PCN – Process Change Notification

Change:	CAB.954_Cable & Connector Tolerances
Date:	2016/05/25
Author	Haley Tsai

Model#	Part Number	Changes
CAB.954_ N Type Jack with O-Ring to 300mm(11.8") 1.37mm IPEX MHFI	CAB.954	Tolerance Change.

Old drawing tolerance

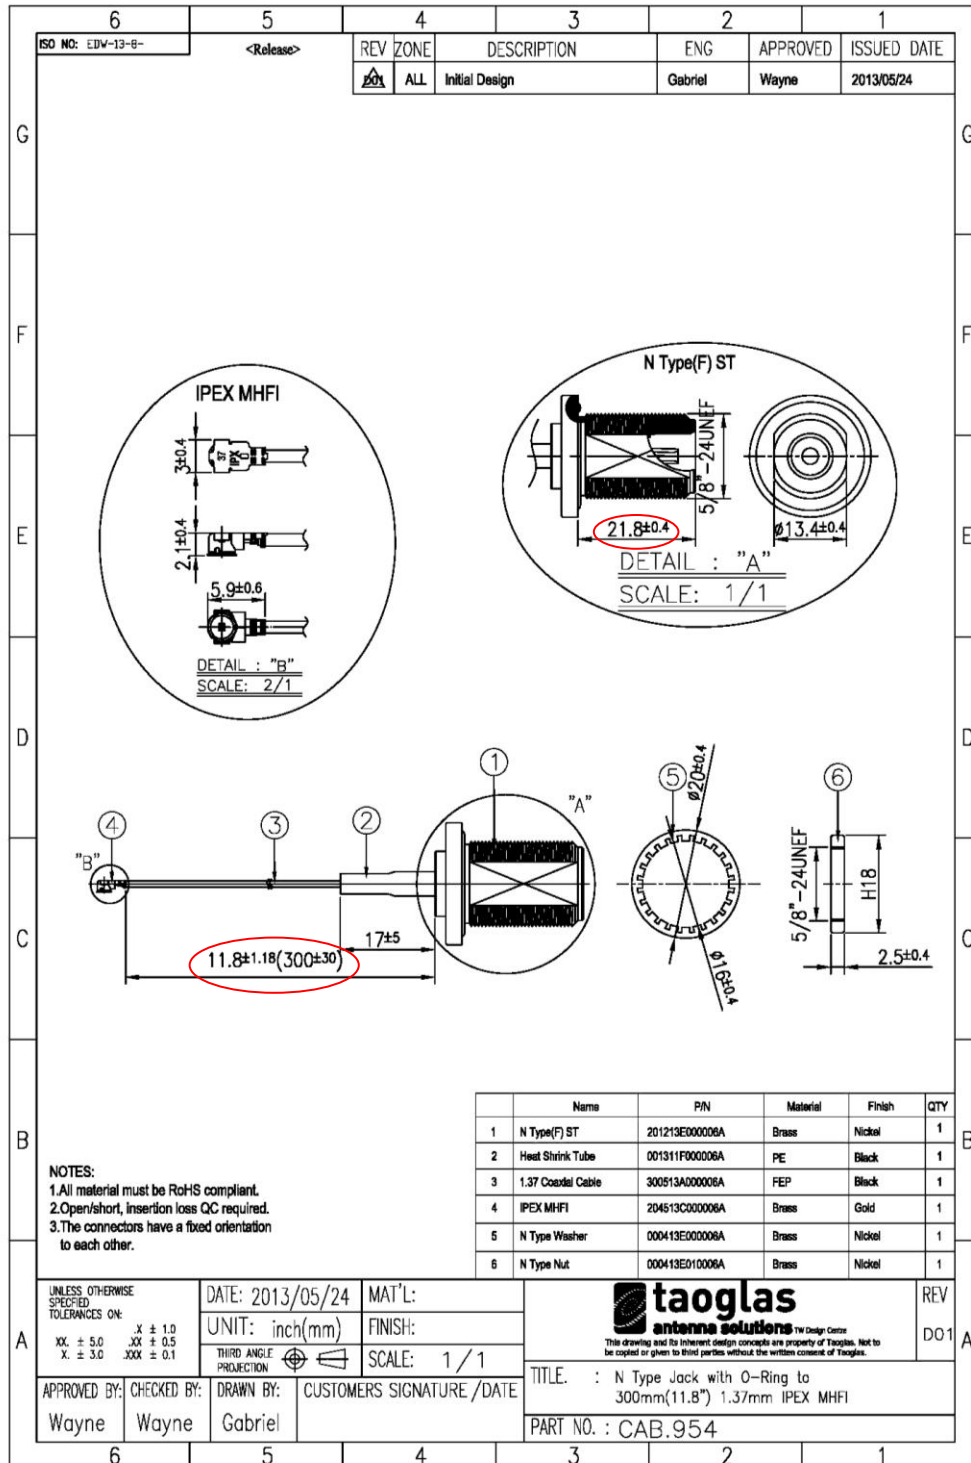
We have improved the cable/connector joint reliability for thinner cables by adding a protective extra metal tube crimped over the cable to protect the solder joint, also updated connector and cable length tolerance.

New drawing tolerance
